<b>Docket Number:</b>	15-AFC-02
<b>Project Title:</b>	Mission Rock Energy Center
<b>TN #:</b>	222101
<b>Document Title:</b>	University of California, Santa Barbara Comments Booth comment on Mission Rock Energy Center
<b>Description:</b>	N/A
<b>Filer:</b>	System
<b>Organization:</b>	University of California, Santa Barbara/Derek Booth
<b>Submitter Role:</b>	Public Agency
<b>Submission Date:</b>	1/5/2018 1:54:30 PM
<b>Docketed Date:</b>	1/5/2018

**Booth comment on Mission Rock Energy Center**

Reference: Mission Rock Energy Center (Docket Number: I 5-AFC-02)

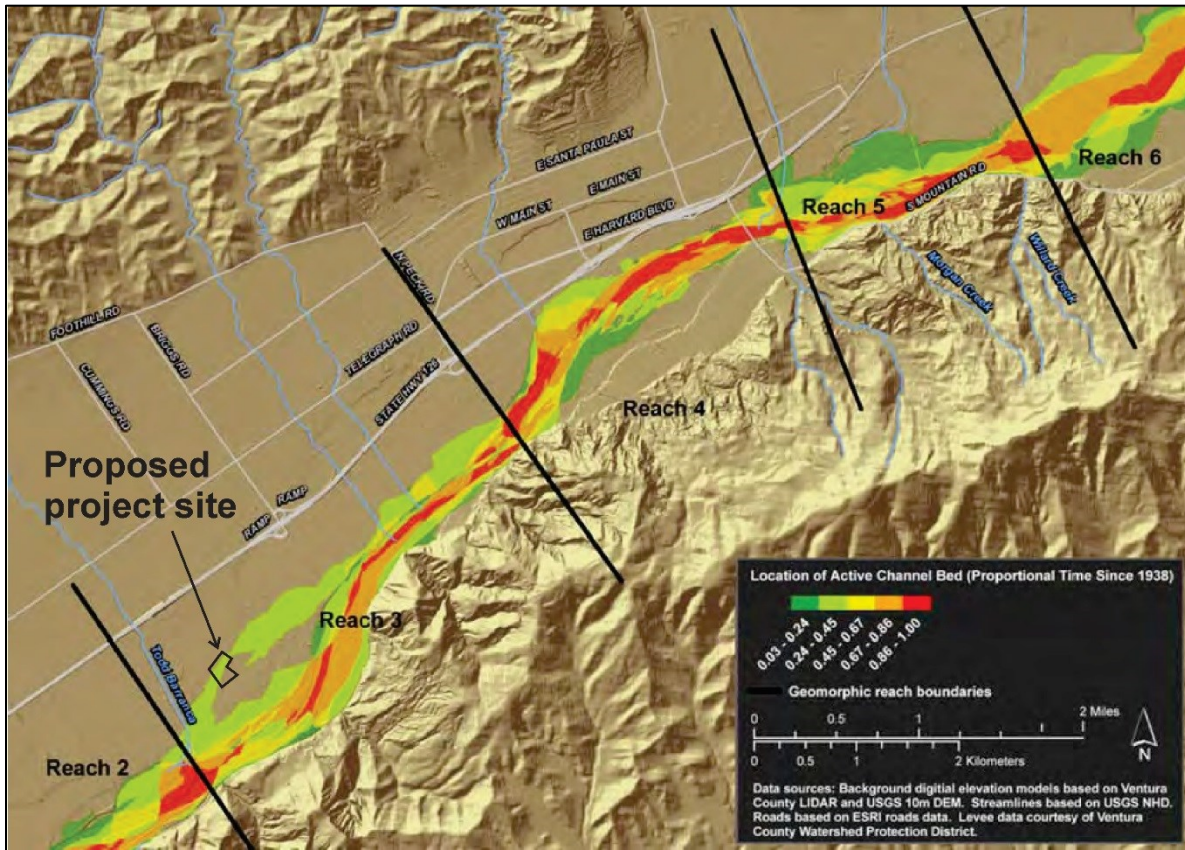
Both include an analysis of the historical channel patterns and behavior of the river throughout the lower Santa Clara River valley, including the project reach. A figure from those reports, with the proposed project site superimposed, demonstrates a key issue that is nowhere addressed in the environmental documents presently available for the project:

Not only is the site acknowledgedly within the FEMA 100-year floodplain, but it lies directly athwart a channel of the Santa Clara River that has been active for over a decade in recent time. Thus, the project's proposal to "mitigate" for flood hazard by importing 10 feet of fill will instead represent a major impact to the river's natural dynamics. This also it emphasizes the unsuitability of this site for a major facility—directly across a recently active channel of the primary river of Ventura County.

Although the site itself is presently in a disturbed condition, its present use is non-permanent and would not obstruct floodwaters nor preclude future opportunities to improve floodplain conditions for the protection of downstream communities through improved flood storage and attenuation. The import of fill and the construction of such a facility would obviously eliminate those options; it would also eliminate any future prospects for restoration of a site located in a key resource reach for the Santa Clara River; which, despite existing degradation, remains the among least impacted rivers of southern California.
